RE: Revised Lansdowne Street Goulburn Planning Proposal (Lot 10 DP 1247119)

I refer to Council's email of 18 October 2019 seeking WaterNSW's comments on a revised Planning Proposal for Lot 10 DP 1247119, Lansdowne Street, Goulburn.

Map 1. Lansdowne Street, Strategic Land and Water Capability Assessment for Residential Sewered Development.

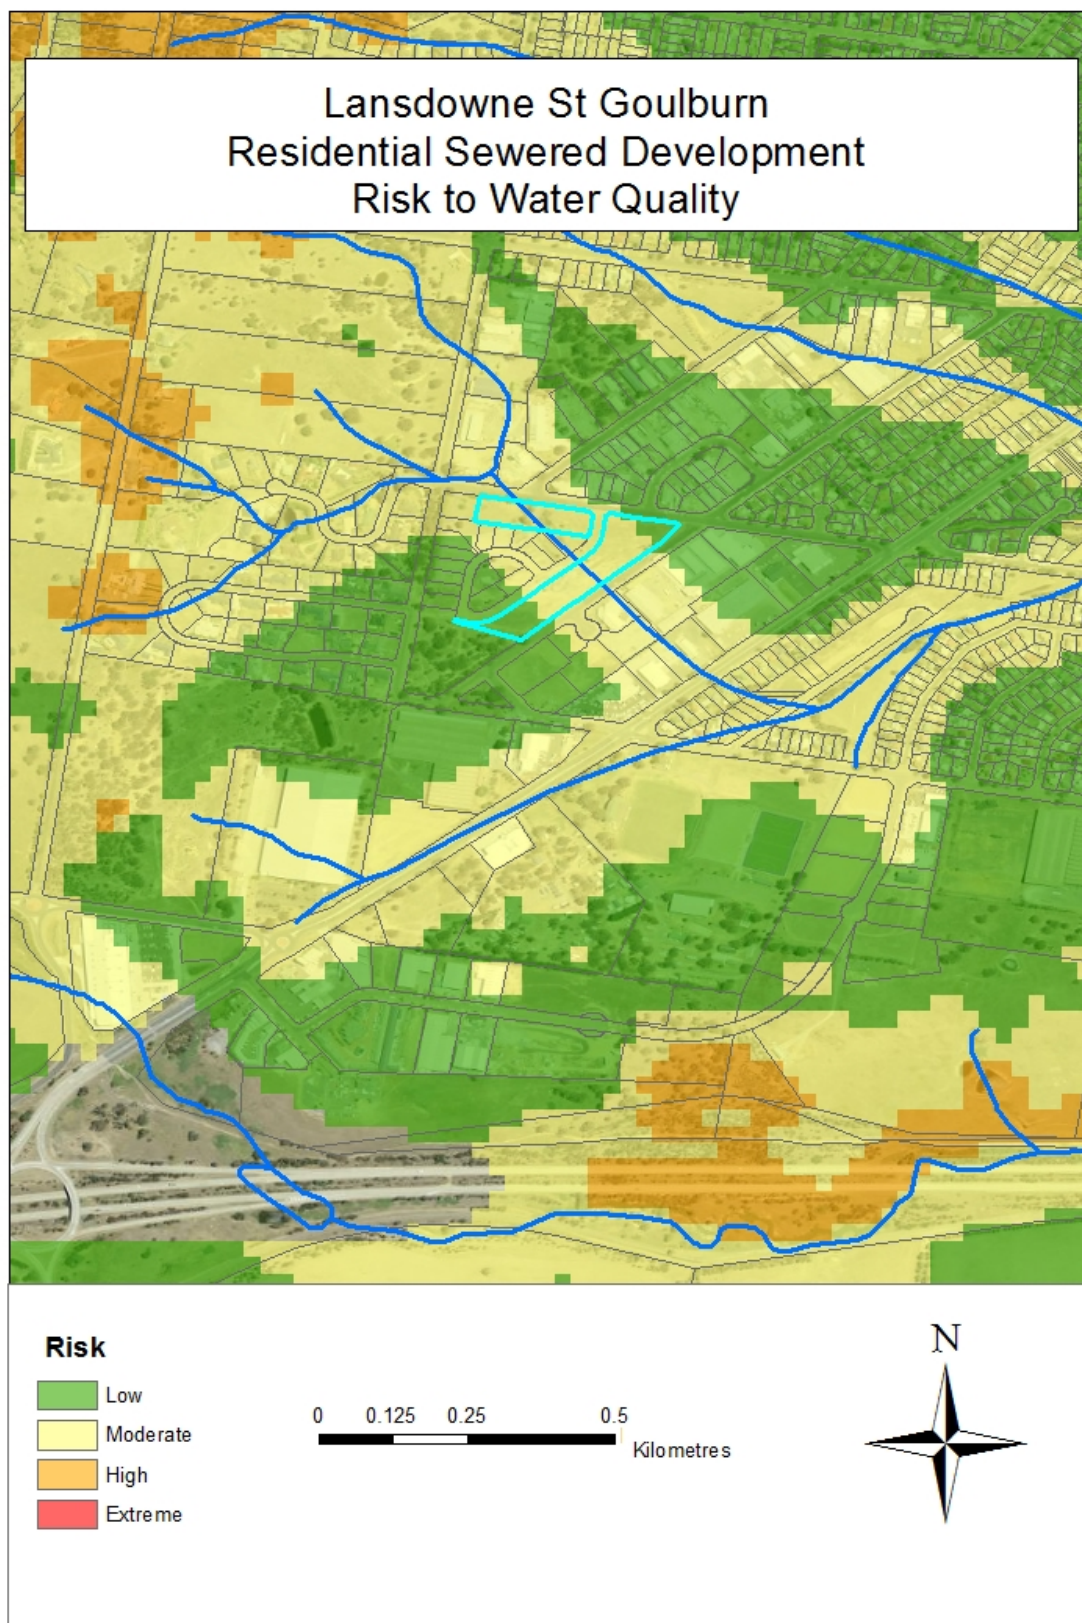
The shape of the site results in both sides of the site being transected by the same 2nd order drainage feature (see Map 1 attached). The Proposal would benefit by recognising the presence of this drainage feature, articulating how it is currently managed, and identifying whether it presents a site constraint to the residential use, subdivision design and lot yield envisaged. In contextualising the drainage feature, Council may wish to consider how that feature was addressed on the adjoining land under the Modification referred to above.

WaterNSW has undertaken its own SLWCA (see Map 1 attached) and compared this with Figure 3. While the boundaries of the two risk ratings are correct, the site has a Low to Moderate risk to water quality, rather than a Nil to Low risk as stated in the Proposal (the yellow areas of the map equate with a Moderate risk to water quality and the green areas a Low risk). The Moderate risk is associated with the location of drainage feature previously described.
